MEMO

To: Kristopher Byrd, Well Construction and Compliance Section Manager
From: Travis Kelly, Well Construction Compliance Coordinator
Subject: Review of Water Right Application G-19074
Date: January 6, 2022

Groundwater Application Review Summary Form

Application # G- 19074

Water-Level Measurements in Nearby Wells of Similar Depth as the Proposed POAs

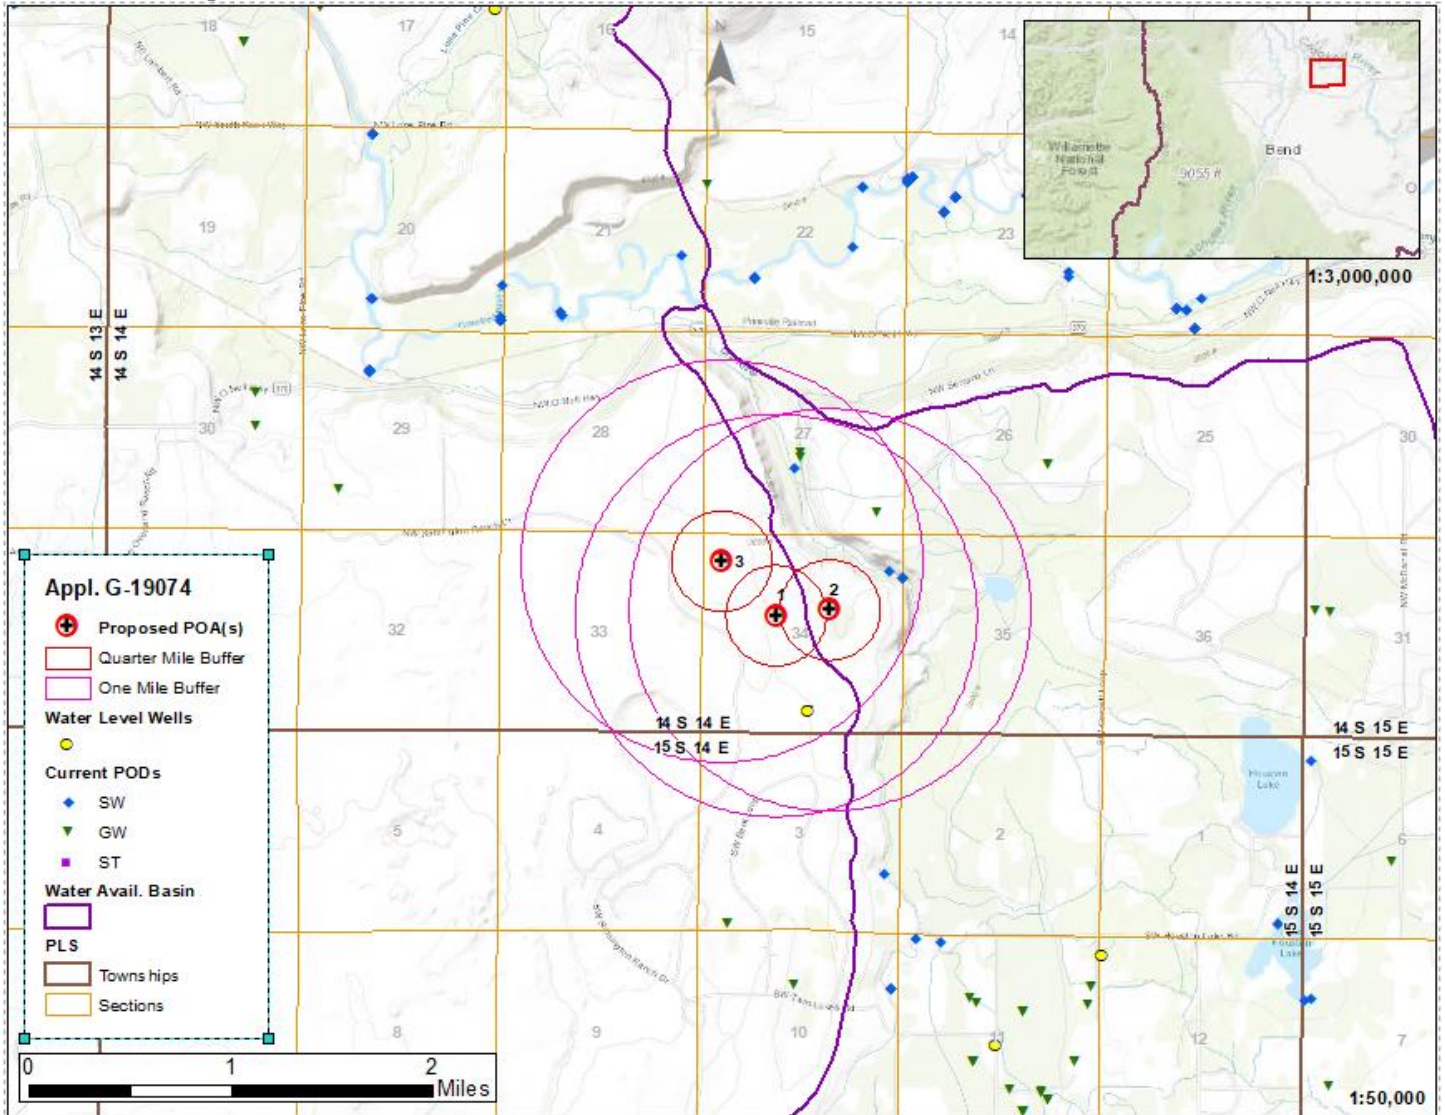
B3. **Groundwater availability remarks:** Water level data from CROO0050431 (POA #1) and a nearby well CROO0000576 track similarly to a long-term observation well CROO0000024 which, although slightly over 4 miles from POA #1, is interpreted to be representing the same aquifer as the proposed POAs. CROO0000024 displays a long-term groundwater level decline of approximately 30 ft since 1995. This trend is similar to trends observed west of Redmond and has been attributed to reduced natural recharge due to long-term climate change and reduced artificial recharge due to canal lining, but also to groundwater pumping (Gannett et al., 2017; Also see memo “Response to Technical Assistance Request: Groundwater Mitigation Program purpose in relation to observed groundwater level trends”, dated August 30, 2021 – available on request). The attribution of this trend, even only partly, to groundwater pumping implies that the groundwater resource in the area is not in equilibrium and that the current rate of groundwater appropriation will not sustain a balance of uses without significantly impairing the function of the aquifer. Therefore, new use in the area, which will contribute to the observed declines, will further impair the function of the aquifer and so is not within the Capacity of the Resource as defined in OAR 690-400-0010
